The Flood Risk Team have raised the following queries:

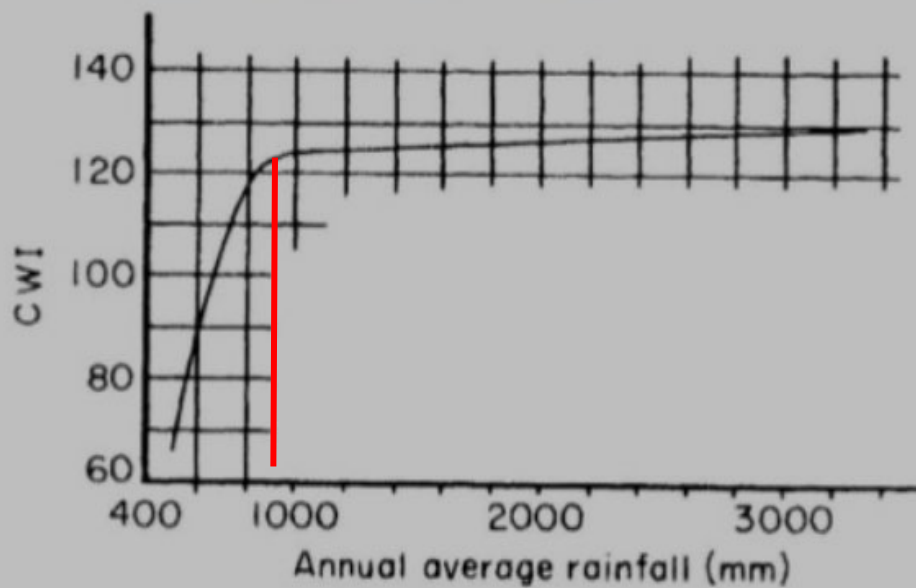
- *Evidence that the drainage system has been designed (unless an area is designated to hold and/or convey water as part of the design) so that flooding does not occur during a 30 (note this was changed from 100 year, based on the temporary carpark only being in use for 18months) year storm rainfall event. Surface water flows should be restricted to ensure that no run-off from the site enters the adjacent Delaunays Road*

The system has been designed for 1 in 30 year event, see calculations.
